**REQUEST FOR CORRECTION OF THE 100-YEAR FLOOD  
IN THE NOVEMBER, 1999 REPORT ON DEER CREEK  
PREPARED BY THE LOS ANGELES DISTRICT,  
U.S. ARMY CORPS OF ENGINEERS**

**Request:**

Recompute the 100-year flow for Day Creek that was computed in the Corps of Engineers' 1999 Report using correctly the 17B Guidelines for skew coefficient computation. With the 1928-1972 record used by the USACE Los Angeles District, the recomputation with skew weighting in accordance with the Bulletin 17B guidelines will result in a 100-year flood flow of 6,664 cfs instead of 3,396 cfs.

Figure 1 District's Computed Peak Flow Frequency Curve for Day Creek

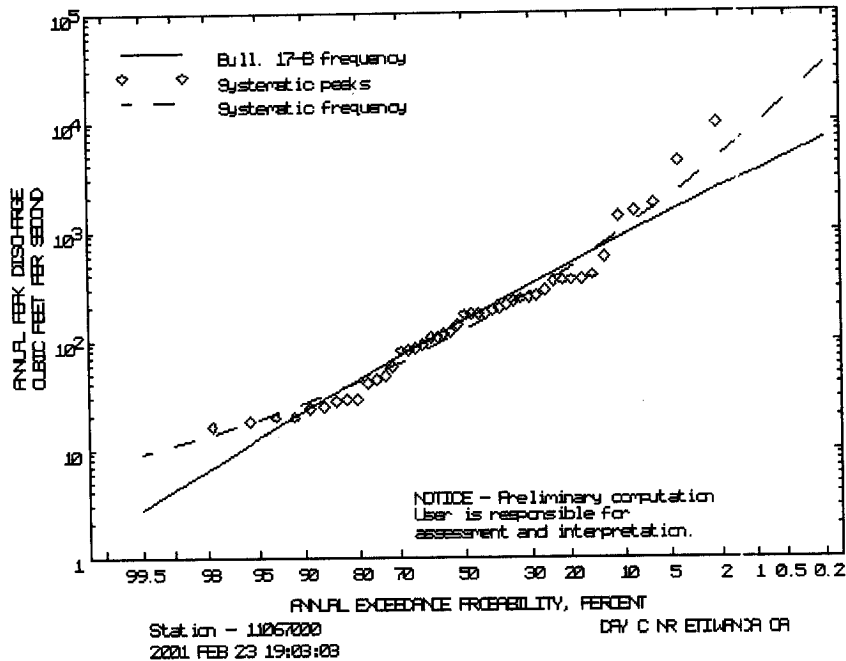
The District did not follow the guidelines in Bulletin 17B that were adopted by Federal Agencies in two respects: the computation of the weighted skew, and the adopted regional skew. The Bulletin 17B procedure is to weight the at-site and regional estimators of the skewness coefficients by the reciprocal of estimates of their mean square errors. (See IACWD, 1981, reproduced in Attachment 1.) Instead the District input a user-specified skew of  $-0.2$  without any weighting with the at-site station skewness coefficient (See Attachment 2). No justification for this user-specified regional skew was provided in the November 29, 1999 report. Given that the District's specified regional skew was negative ( $-0.2$ ), and the at-site skewness estimator was very positive ( $+0.70$ ; see Attachment 2 at the line entitled "SYSTEMATIC RECORD", under the column heading "SKEW"), the result is a much smaller computed value of the 100-year flood than would be obtained were the Bulletin 17B guidelines respected ( $+0.44$ ; see Attachment 3 at the line entitled "BULLETIN 17B ESTIMATE" under the column heading "SKEW").

Specifying a negative skew coefficient in this manner deviates from the guidelines in Bulletin 17B which the District claims to have followed in their report. Therefore, a computed 100-year flood value of 3,396 cfs for Day Creek is not correct based on the Bulletin 17B Guidelines.

The statistical analysis for the Day Creek Stream Gage done by the Corps of Engineers in their November 1999 report is shown in Figure 1 below. The downward-curving solid line is the computed flow frequency curve and the diamond shapes are the actual measured peak flow data.

The trend of the measured peak flow data clearly bends upward (positive skew) while the calculated line bends slightly downward (negative skew). The computed 100-year flow for Day Creek in Figure 1 is 3,396 cfs (See Attachment 2.)

Figure 2 Flow Frequency Curve for Day Creek Using Bulletin 17B Skew.

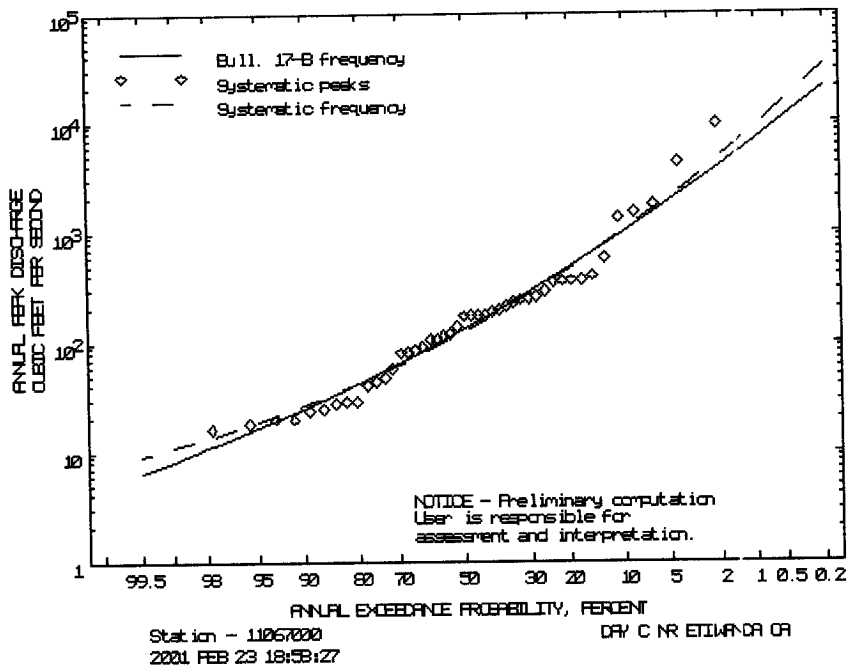
Bulletin 17B recommends using a weighted skew coefficient, which combines regional and site-specific skew values. The USGS computer program PEAKFQ does this weighting automatically by entering the stream gage data along with the latitude and longitude of the gage. Re-computing the flood frequency data using the Bulletin 17B guidelines results in a peak flow frequency curve with a skew of +0.44 that is shown in Figure 2. This new distribution is more consistent with the trend of the measured data. This approach results in a 100-year peak discharge of 6,664 cfs (See Attachment 3), almost twice the value obtained when the skew value of -0.2 was adopted. And, the new curve still falls below the five largest observed peaks.
